FORM APPROVED
OMB NO. 1004-0137
Expires: January 31, 2018**SUNDRY NOTICES AND REPORTS ON WELLS**
Do not use this form for proposals to drill or to re-enter an abandoned well. Use form 3160-3 (APD) for such proposals.

XTO Permian Operating, LLC requests to change the casing & cement design per the attached drilling program.

Poker Lake Unit 13 DTD 127H - 30-015-45823
Poker Lake Unit 13 DTD 907H - 30-015-45829
Poker Lake Unit 13 DTD 707H - 30-015-45828

DRILLING PLAN - BLM COMPLIANCE
(Supplement to BLM 3160-3)

13-3/8" x 9-5/8" x 5-1/2" 10M RSH-2 Wellhead
Assembly With T-EBS-F Tubing Head

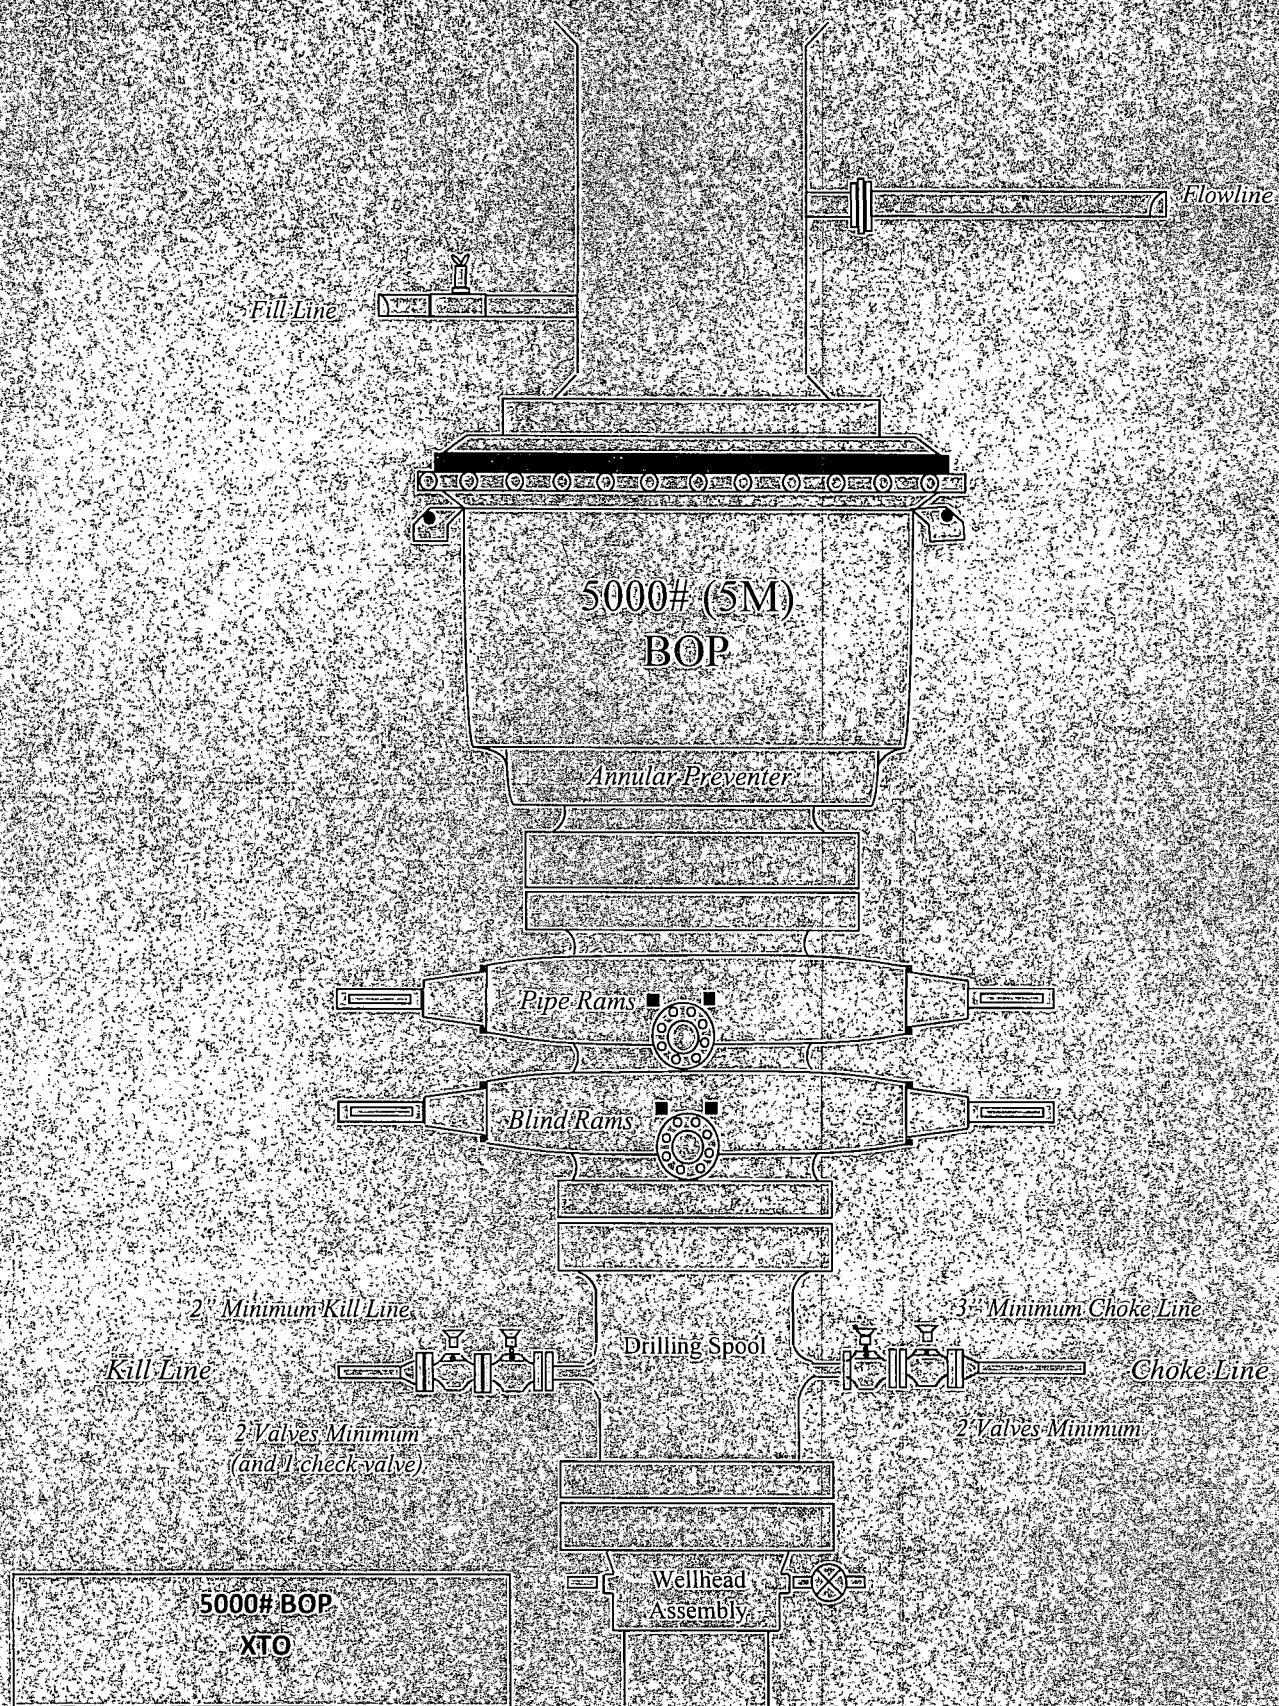
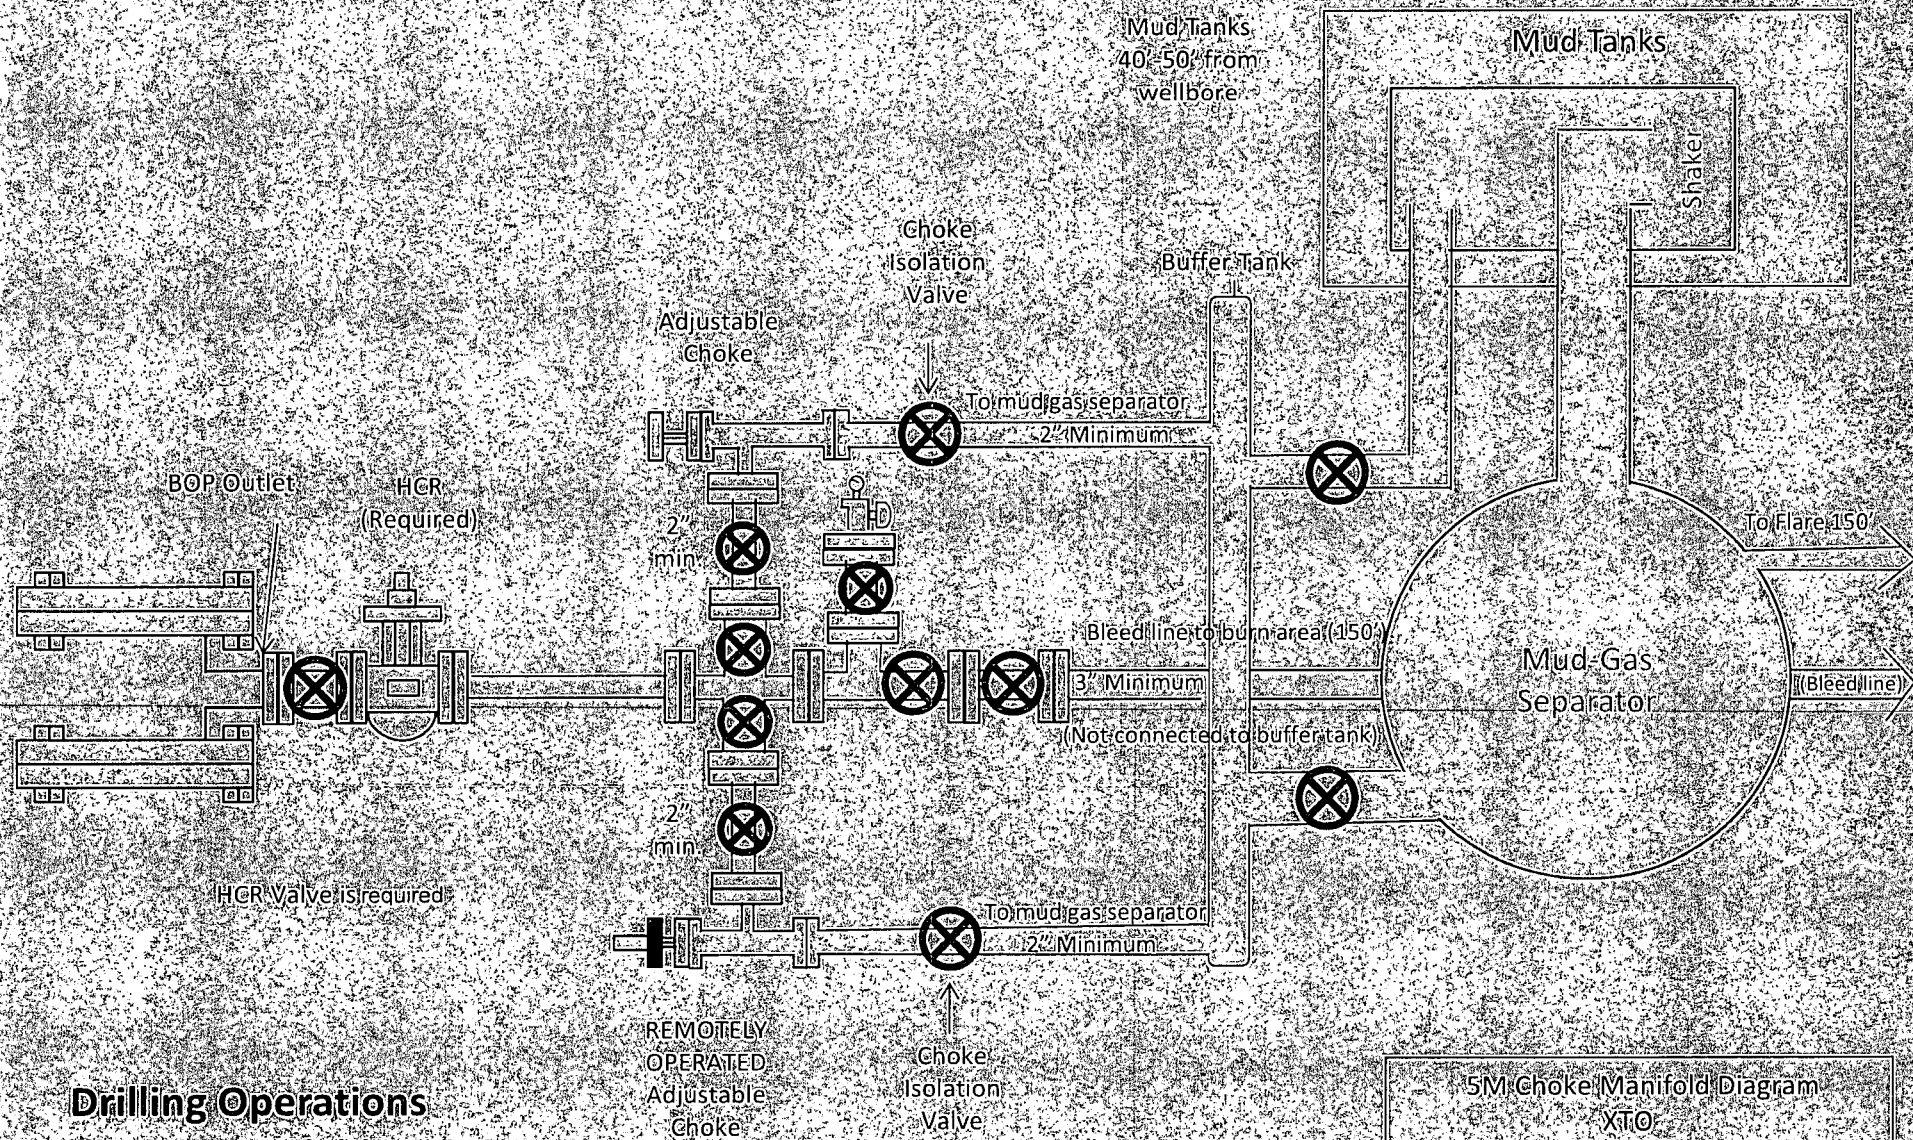
Permanent Wellhead = GE-RSH Multibowl System

A. Starting Head (RSH System) 13-3/8" SOW bottom x 13-5/8" 5M top flange

B. Tubing Head 13-5/8" 5M bottom flange x 7-1/16" 10M top flange

- Wellhead will be installed by manufacturer's representatives
- Manufacturer will monitor welding process to ensure appropriate temperature of seal
- Operator will test the 9-5/8" casing per Onshore Order 2
- Wellhead manufacturer representative may not be present for BOP test plug installation

3. **Operator has proposed a multi-bowl wellhead assembly. This assembly will only be tested when installed on the surface casing. Minimum working pressure of the blowout preventer (BOP) and related equipment (BOPE) required for drilling below the surface casing shoe shall be 5000 (5M) psi.**

- a. **Wellhead shall be installed by manufacturer's representatives, submit documentation with subsequent sundry.**
 - b. **If the welding is performed by a third party, the manufacturer's representative shall monitor the temperature to verify that it does not exceed the maximum temperature of the seal.**

- c. **Manufacturer representative shall install the test plug for the initial BOP test.**
 - d. **Operator shall perform the intermediate casing integrity test to 70% of the casing burst. This will test the multi-bowl seals.**

GRADE D PRESSURE TEST CERTIFICATE

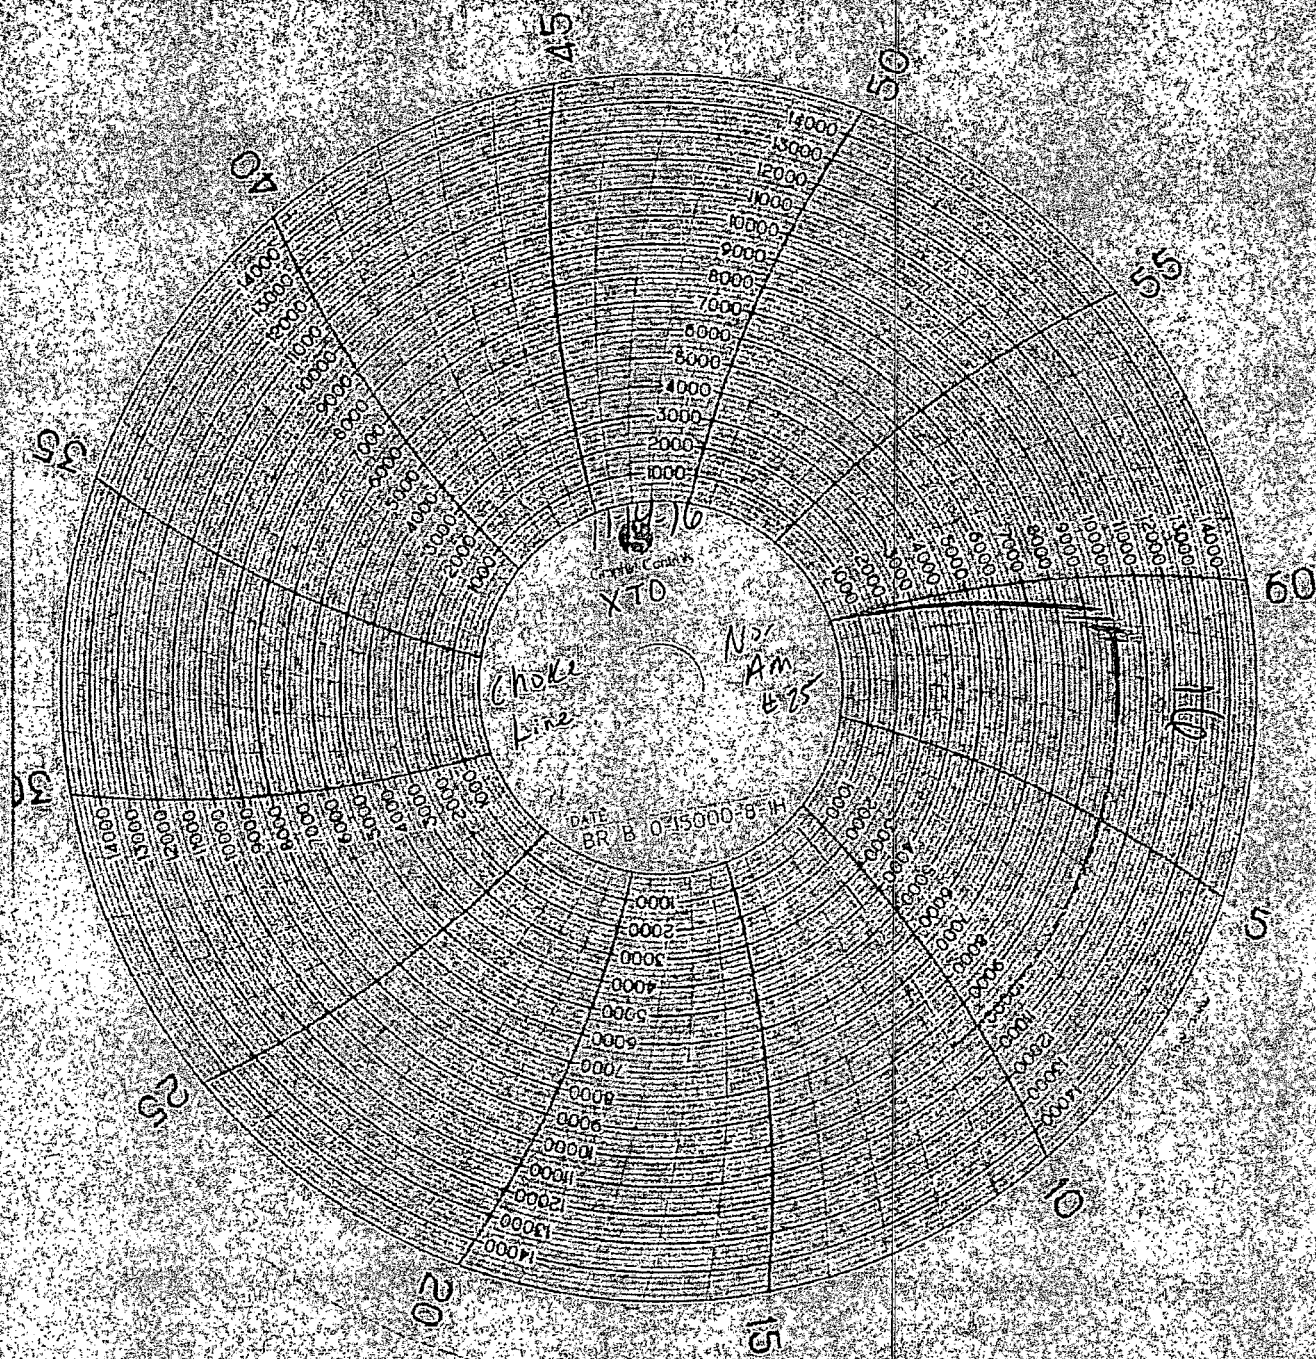
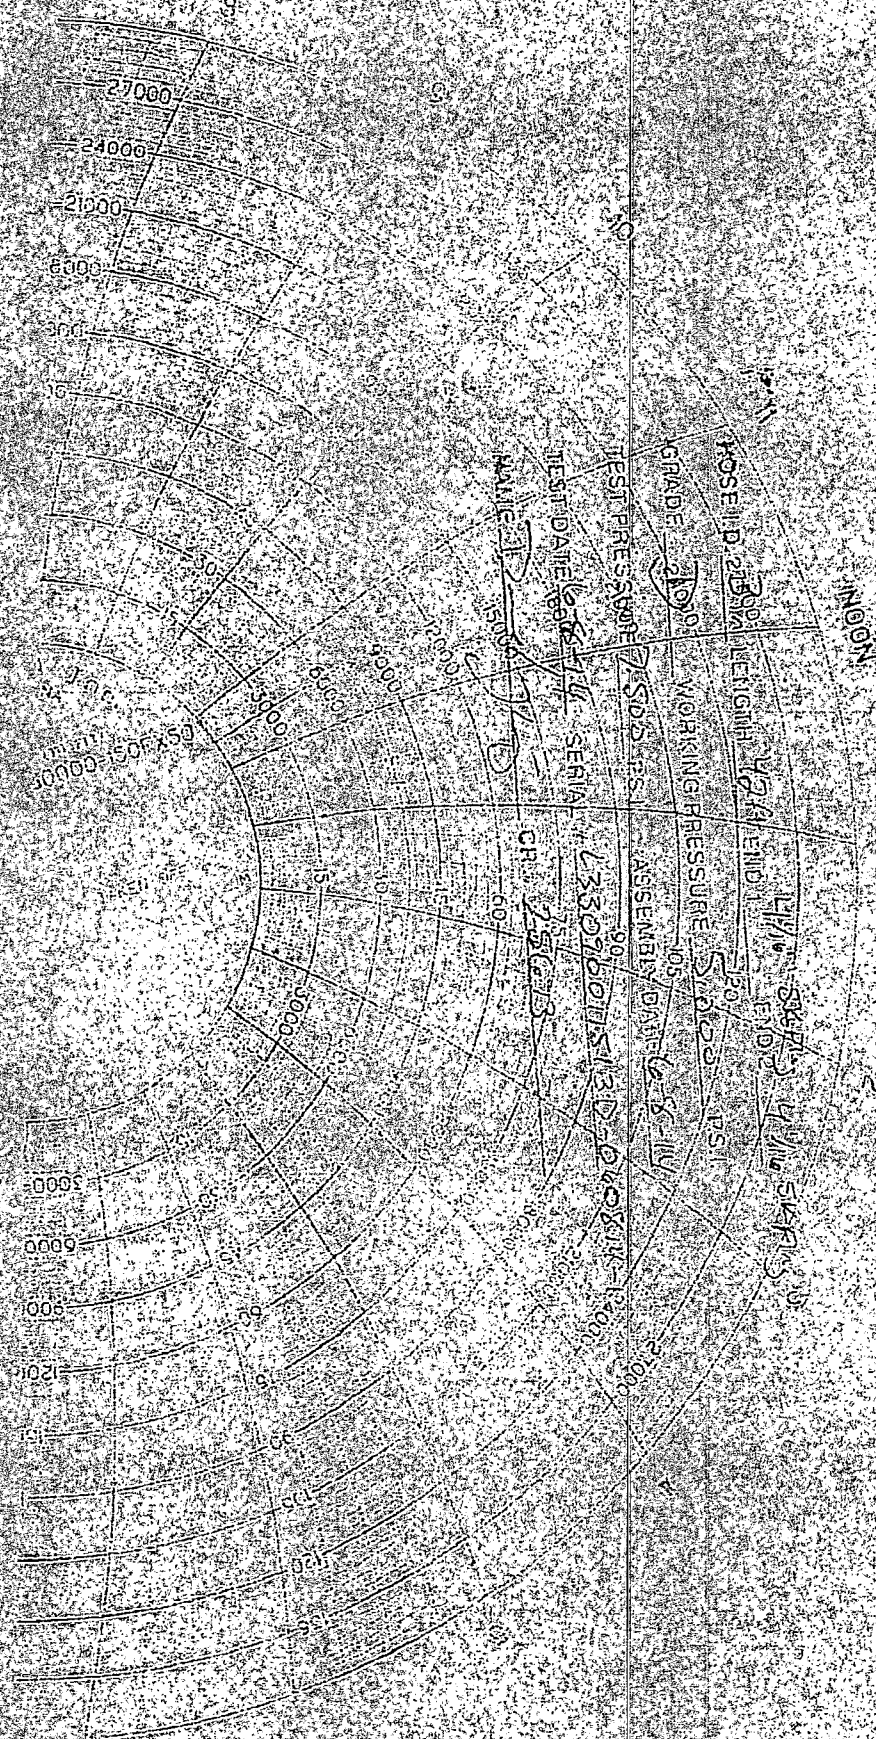
A variance is requested to allow use of a flex hose as the choke line from the BOP to the Choke Manifold. If this hose is used, a copy of the manufacturer's certification and pressure test chart will be kept on the rig. Attached is an example of a certification and pressure test chart. The manufacturer does not require anchors

2. Variance approved to use flex line from BOP to choke manifold. Check condition of flexible line from BOP to choke manifold, replace if exterior is damaged or if line fails test. Line to be as straight as possible with no hard bends and is to be anchored according to Manufacturer's requirements. The flexible hose can be exchanged with a hose of equal size and equal or greater pressure rating. **Anchor requirements, specification sheet and hydrostatic pressure test certification matching the hose in service, to be onsite for review. These documents shall be posted in the company man's trailer and on the rig floor.** If the BLM inspector questions the straightness of the hose, a BLM engineer will be contacted and will review in the field or via picture supplied by inspector to determine if changes are required (operator shall expect delays if this occurs).
